**Submission of Further Information (FI)**

**Temporary Shop and Services (Retail Shop for Hardware Groceries and Construction Materials) with Ancillary Facilities for a Period of 5 Years in “Residential (Group D)” Zone, Lots 670 (Part), 671 (Part), 673 (Part), 674, 675, 676, 677 (Part), 679 (Part) and 680(Part) in D.D. 106 and Adjoining Government Land, Yuen Long, New Territories (Application No. A/YL-KTS/1101)**

**Further Information for Planning Application No. A/YL-KTS/1101****Response-to-Comments****Comments from Commissioner for Transport**

Plan 5.1a  
( P 22068A )

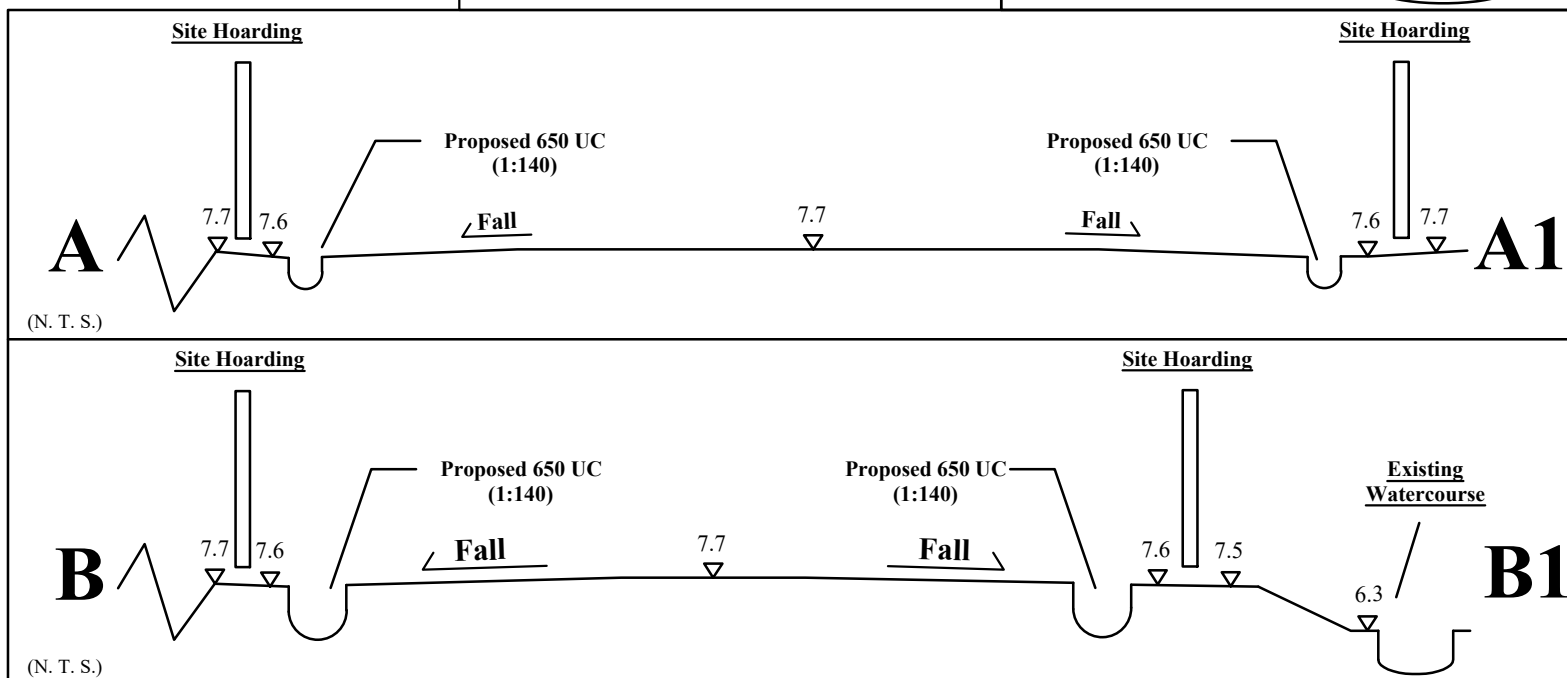
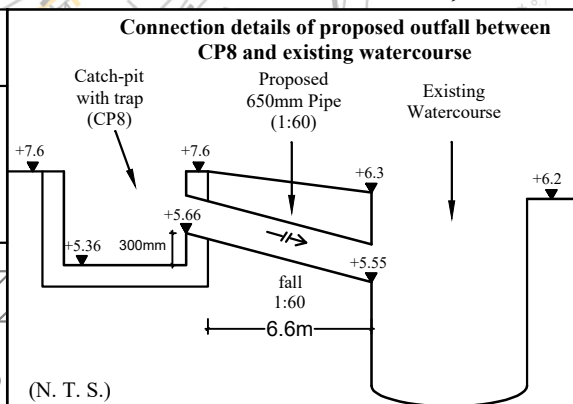
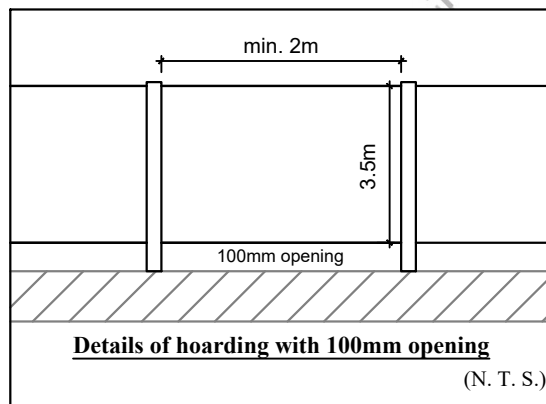
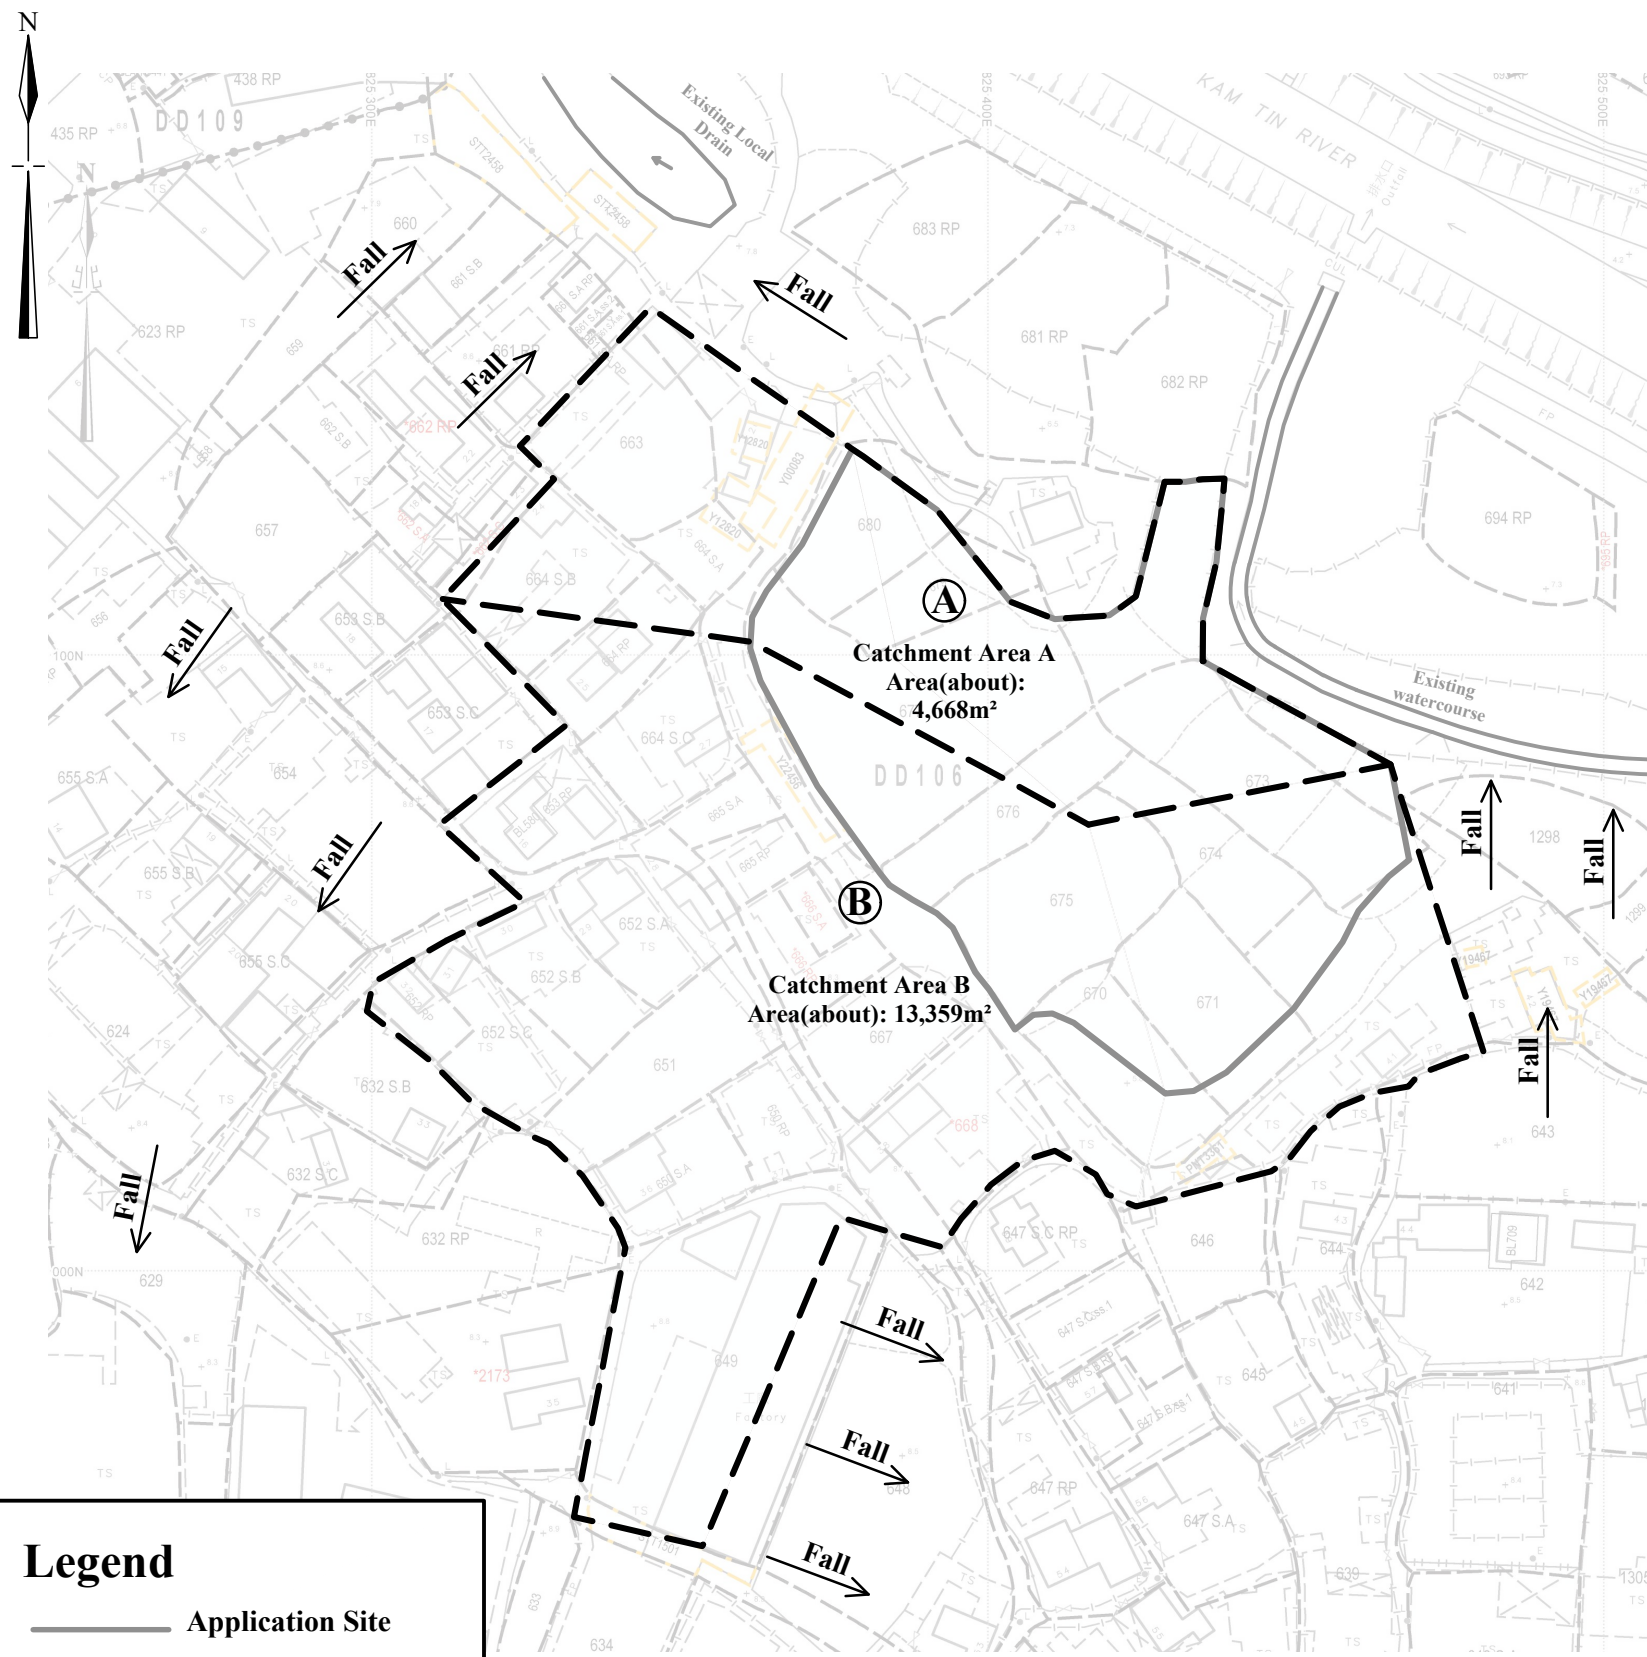
<b>III.</b>	<b>Comments</b>	<b>Responses</b>
1.	The proposed connection details at both discharge points with L-shape downpipe as shown on drainage plan (Plan 5.1a) is not typical arrangement. Please review the details of the proposed discharge connection accordingly.	The details of the proposed discharge connection are reviewed. Please refer to Plan 5.1a.

2.	Referring to the connection details in Plan 5.1a, the ground level at the bank of the existing DSD's channel at both sides should be similar. In this regard, the proposed invert level at both discharge points will be higher than the existing ground level, please review.	The proposed invert level at the discharge points is reviewed. Please refer to Plan 5.1a.

3.	In general, only one terminal manhole/last catchpit with sand trap will be provided for each development. Please review.	The number of last catchpits for the development is revised to one last catchpit only. Please refer to Plan 5.1a.

5.	According to R-to-C, it is noted that no site formation/levelling works to be carried out under this application. Please state the above on the drainage plan (Plan 5.1a) for record.	Noted. Please refer to Plan 5.1a.

6.	To improve the drainage performance, please consider increasing the size of the proposed 400mm discharge pipes and peripheral surface channels accordingly.	The discharge pipe after the last catchpit will be upgrade to 650mm pipe. Please refer to Plan 5.1a.

**Note:** No site formation/levelling works to be carried out under this application. Thus, the existing ground levels is equal to the proposed ground levels.

<b>1:1000 (A4)</b>	<b>Layout Plan</b>	<b>Goldrich Planners &amp; Surveyors Ltd.</b>
<b>April 2026</b>	Lots 670(part), 671(part), 673(part), 674, 675, 676, 677(part), 679(part) and 680(part) in DD.106 and adjoining Government Land	<b>Plan 3a ( P 22068A)</b>

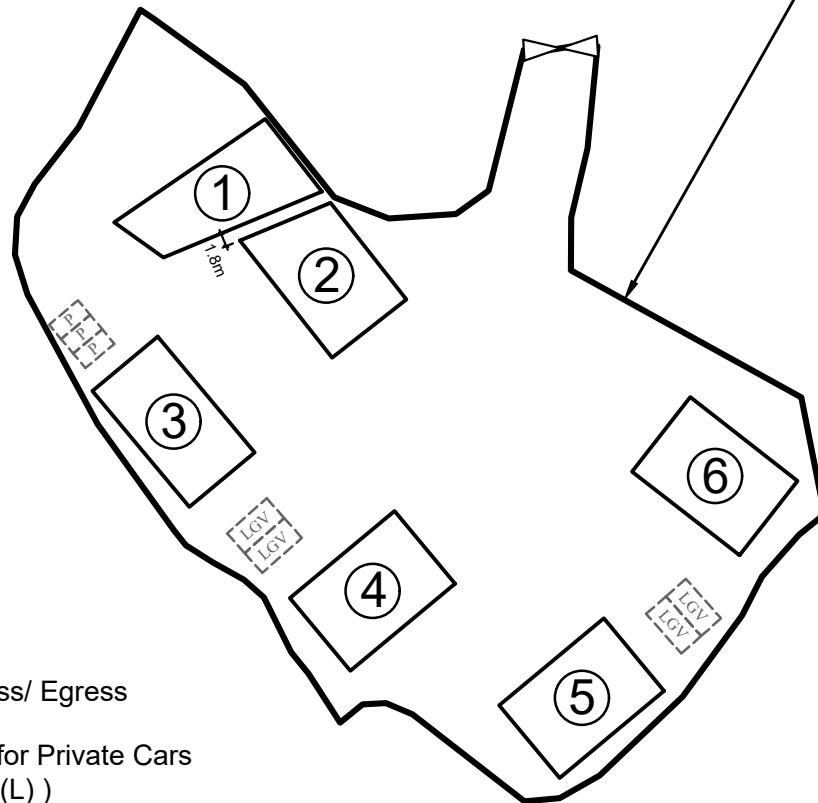
<b>II.</b>	<b>Comments</b>	<b>Responses</b>
1.	Based on the applicant's submission, the proposed use would not involve dusty operation but it would cause traffic of heavy vehicles (i.e. medium goods vehicles). According to our review, there are residential structures within 100m from the boundary of the Site. As such, according to the revised 'CoP', it is anticipated that the proposed use would cause environmental nuisance to the residential structures nearby. Therefore, we do not support the application from environmental planning perspective.	Light goods vehicles instead of medium goods vehicles will be adopted for the daily operation of the Proposed Development. Please refer to the revised Layout Plan (Plan 3a) for details.
